CASE NO. 006-V-21
SUPPLEMENTAL MEMORANDUM #1
May 12, 2021

Petitioner: **Stephen Mechling**

Subject Property: **The 6,534 square feet Lot 5 of Block 12 of the Original Town of Seymour, commonly known as the residence at 105 East Center Street, Seymour**

102 S SWERMA Case 006-V-21 ZBA 05/18/21 Supp Memo #1 Attachment A Page 3 of 8

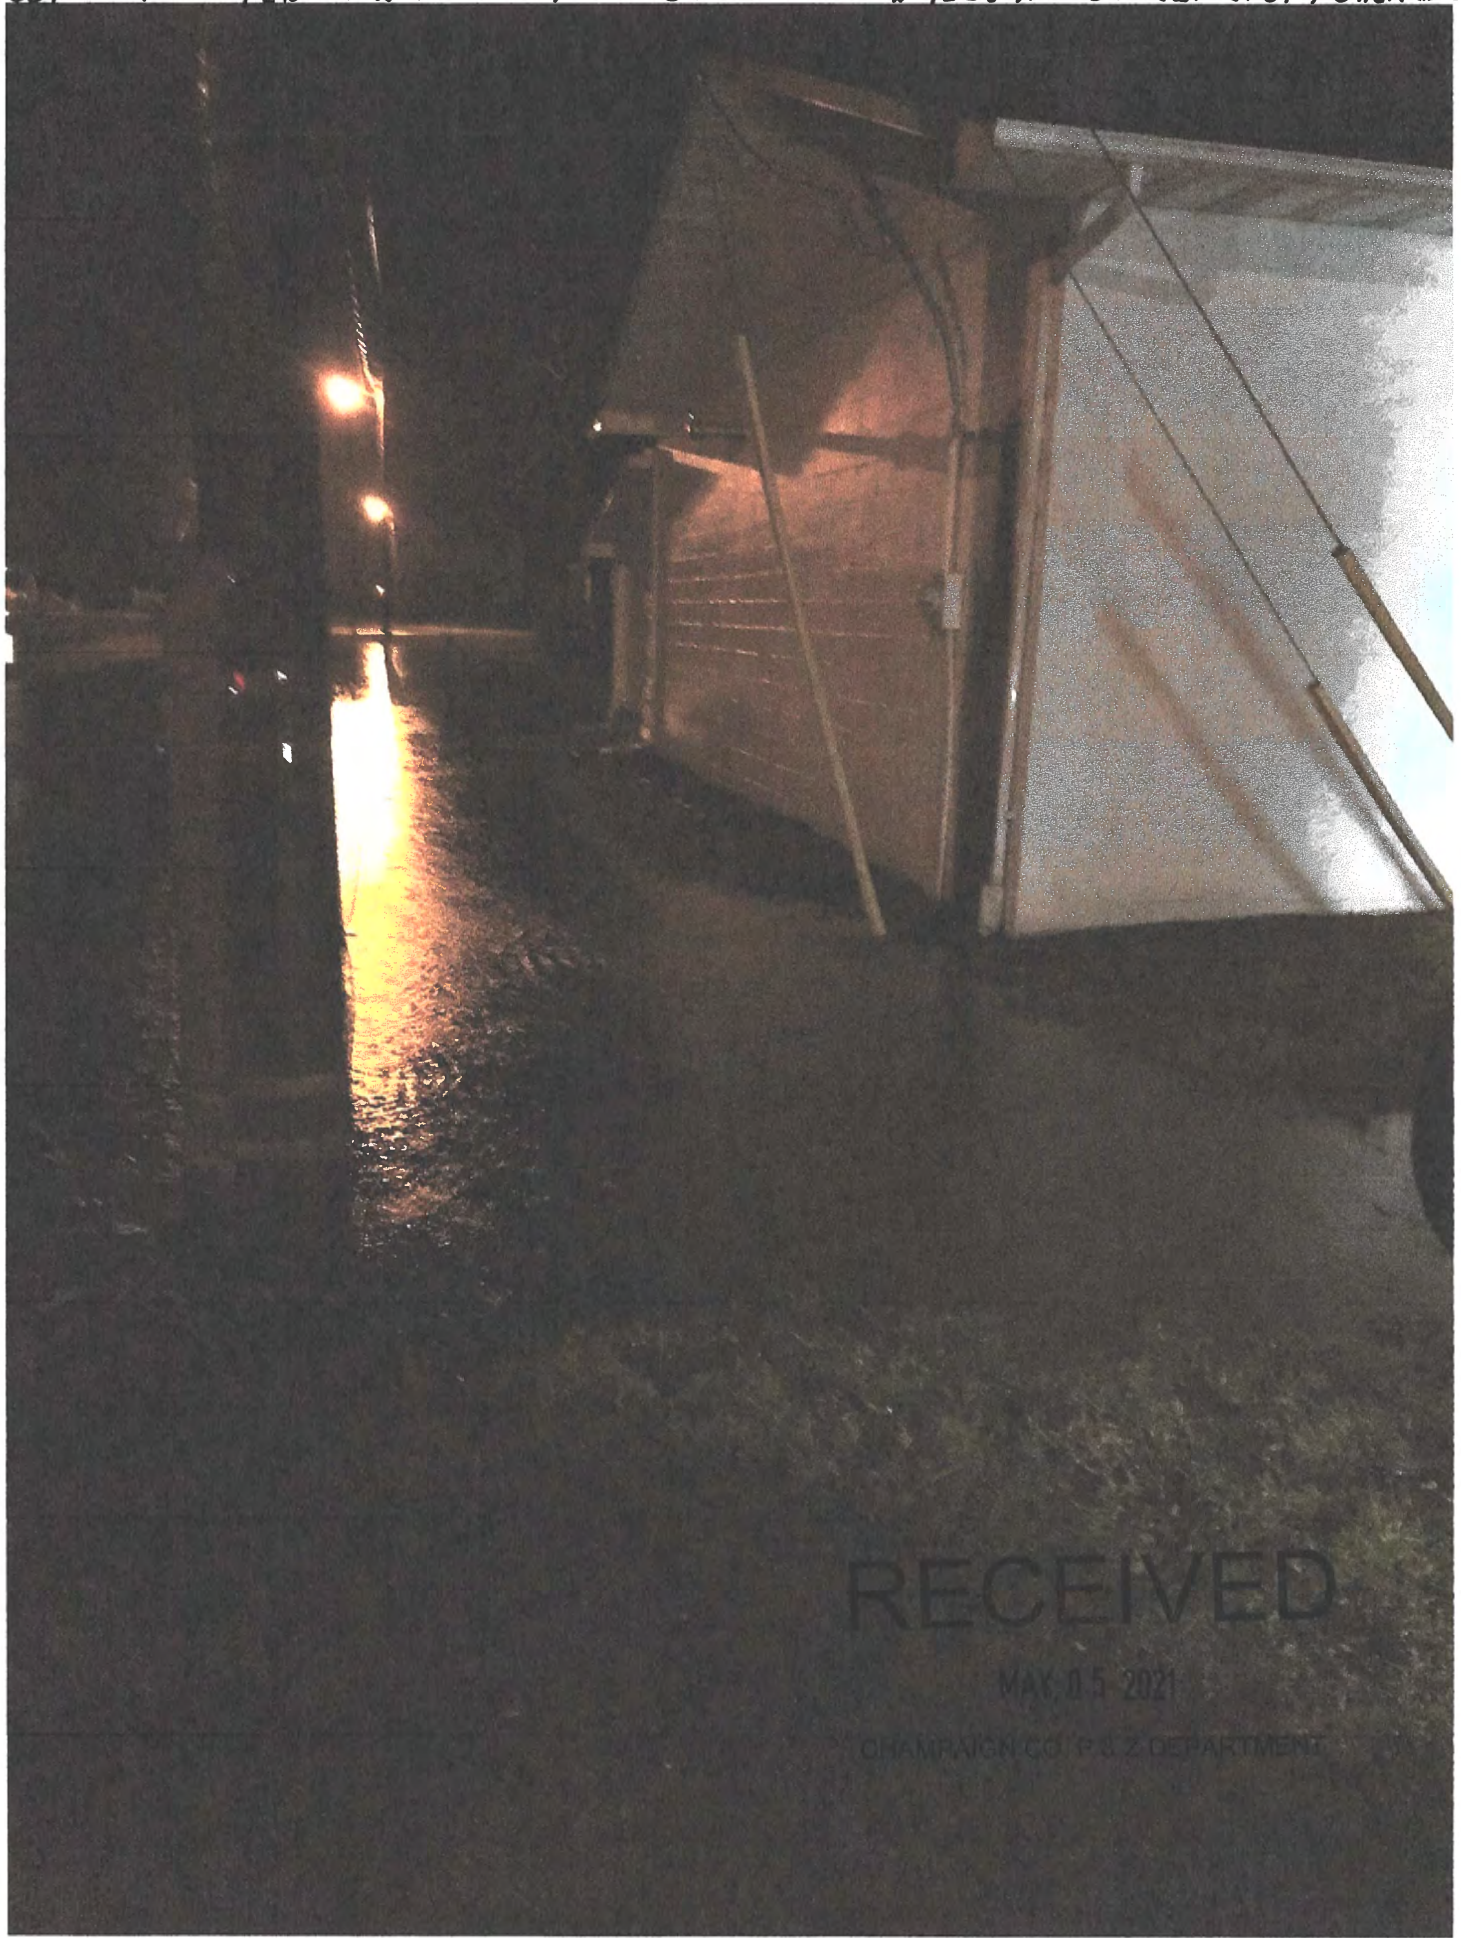
12. This can increase flooding and damage to properties down stream as shown in pictures of 112 E South St., 102 South Sherman and 110 E South St.
13. Approximately for every 1000 square feet of surface 550 gallons of water can be collected for every inch of rain. The Seymour area receives on an average of 40 inches of rain and 20 inches of snow per year. (<http://pccd.org.rainwcandbestplaces.net>). With new 40' by 70' garage and 70' by 32' approaching driveway this could amount to one million two hundred gallons of run off on an **average** year. It would be more run off if the eaves stick out one or two feet past proposed the 40' by 70' foot print, which would extend past the owners property line to the south with a two foot set back, and cover increase the area for water run off.
